STAFF RECOMMENDATION

NCPC File No. 7096

FORT BELVOIR – NORTH POST POST EXCHANGE SHOPPING CENTER

April 28, 2011

Figure 3: Proposed new Post Exchange Shopping Center

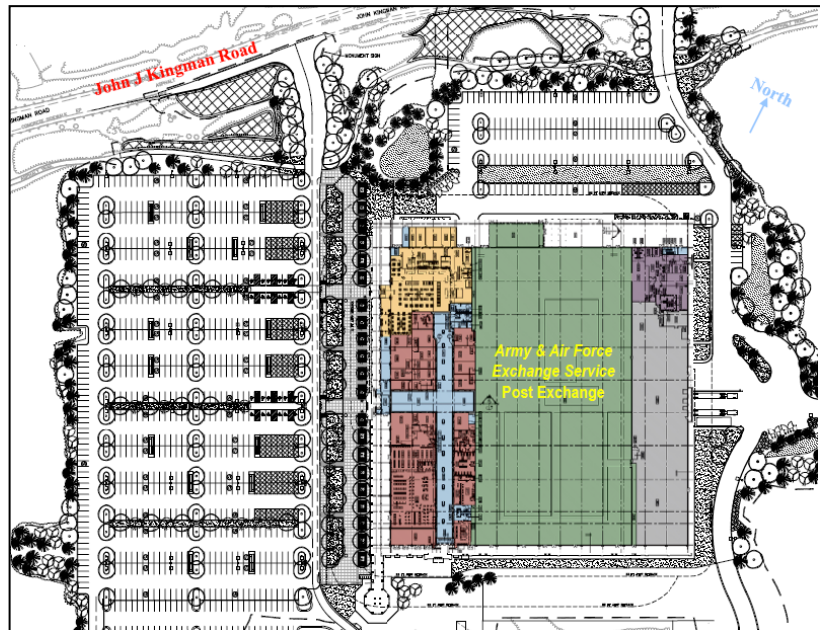
Disapproves the final site and building plans for a new Post Exchange Shopping Center at Fort Belvoir, as shown on NCPC Map File No. 2204.10(38.00)43328, as the proposal is not fully responsive to the Commission's concerns expressed at the preliminary review stage regarding the substantial tree loss resulting from the project and the overall site planning of the Post Exchange and North Post town center.

Staff has reviewed the applicant's response to the Commission's preliminary report and finds that the additional information provided, specifically regarding the removal of trees and overall site planning of the North Post Town Center, does not adequately respond to the Commission's concerns expressed in its prior action of April 7, 2011. Therefore, staff recommends that the Commission disapprove the final site and building plans for the new Post Exchange Shopping Center at Fort Belvoir. Staff acknowledges that the Army has made improvements to the project's design, in large part, in response to the Commission's July 2010 comments on the concept submission. However, the overall site planning of the North Post Town Center as a single-level, car-oriented district that does not maximize its use of already disturbed land, but rather requires the removal of almost 5,000 trees, continues to be at odds with the Commission's preliminary action on the project. Although, the project will be located near other commercial and residential uses, the overall planning and design of the North Post Town Center fails to establish a holistic, pedestrian-friendly environment, similar to the successful Fort Belvoir South Post Town Center. In addition, other town centers located throughout the region such as National Harbor (National Harbor, MD), Reston Town Center (Reston, VA), and Washingtonian Center (Gaithersburg, MD), demonstrate that these types of developments can be successful in the absence of transit, and be designed in a manner that utilizes structured parking and accommodates typical "big-box" type retailers in multi-story buildings.

- The size of the proposed AFFES Post Exchange is based on the number of anticipated future customers, and the new store will be one of the largest exchanges in the United States. In response to NCPC and Fairfax County comments, the new store's parking was reduced from 1,080 to 985 spaces (95 spaces less than authorized); the Belvoir PX will provide employee shower facilities (which are not required); the parking areas are designed with pervious pavement (no other PXs have this); and the pervious pavement will be concrete (versus asphalt), which will significantly reduce the heat island affect of parking areas.

- Easy driving access to the shopping center site will be provided for the large off-post population that is served by the current PX shopping center (96% customers come from off-post, 4% customers come from on-post). A parking reduction for the shopping complex would adversely impact the ability for patrons to find parking at the new shopping complex and result in loss revenue to the Army, the AAFES (PX), the Defense Commissary Agency (DeCA), and the installation support services.

- There is little opportunity to reshape the Post Exchange (PX) shopping center and Commissary portions of the North Post Town Center Design however, the remainder of the Town Center's design is a part of the Installation's future development master plan and could be re-shaped/revised. The future Post Exchange shopping center and Commissary are key elements of the future North Post town center, and have been located immediately adjacent to one another to provide one-stop shopping for the large off-post population served. The existing South Post town center and future planned North Post Town Center is similar in area, and they both have/will have multiple uses.

- Structured parking was considered in the initial planning for the shopping center however, structured parking was deemed too costly to meet the project's ROI requirements. Two-thirds of the net earnings from the AAFES business is returned to the local installation's Morale, Welfare and Recreation (MWR) fund, which supports these types of programs.

- The project's tree loss mitigation was developed based on the Memorandum of Agreement between the Installation and AAFES, which is a function of cost, Return on

Investment (ROI), and the project's return to the MWR fund. The installation's selection of 2.5" trees is based on past experience with this sized tree, which affords the best combination of instant positive landscape impact and survival rate, given the proper care.

- Section 1510.7² of the referenced D.C. standard requires one canopy tree for every five parking spaces, which would require 197 trees for the 985 parking spaces in the current shopping center design. The Installation Design Guidelines (IDG) requires trees for every 10 parking spaces. There are currently 191 canopy and evergreen trees scheduled located within and around the two parking lots in the proposal. Though the current site design will utilize a combination of canopy and evergreen trees, compared to the District's requirements which mandate the use of canopy trees, the landscape plan is considered to be consistent with the IDG and with the D.C. requirement for proper screening of large parking areas.

- A tree reforestation plan will be addressed in the Real Property Master Plan update as requested. Tree replacement is also a part of the Installation's Natural Resource Management Plan.
